# UNITED STATES PATENT AND TRADEMARK OFFICE

10/523,871

Kazuyuki Nakano

<b>Office Action Summary</b>	<b>Application No.</b> 10/523,871	<b>Applicant(s)</b> NAKANO ET AL.	
	<b>Examiner</b> Mohammed Hasan	<b>Art Unit</b> 2873

**FIG. 2**

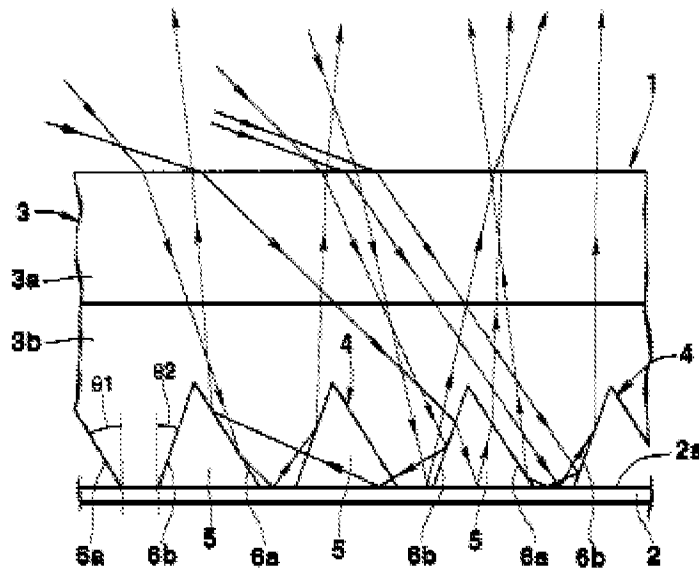
Regarding claim 1, Higuchi discloses (refer to figure 1-14) an illumination apparatus in which a through-hole for detection is formed at a center portion, and which irradiates diffused light and directional light to an object to be detected, characterized in that at least an annular diffusion plate which diffuses light, light source which were disposed annularly, and an annular reflection plate which reflects light from the light source to the side of said object to be detected, are disposed in the order from the side of object to be detected, and diffused light is generated by irradiating light from said light source to the object to be detected through said diffusion plate (40) , and light from said light source is reflected by reflection plate(1) and then, irradiated to the object to be detected (column 6, lines 40-65, column, 26, lines 10-45).
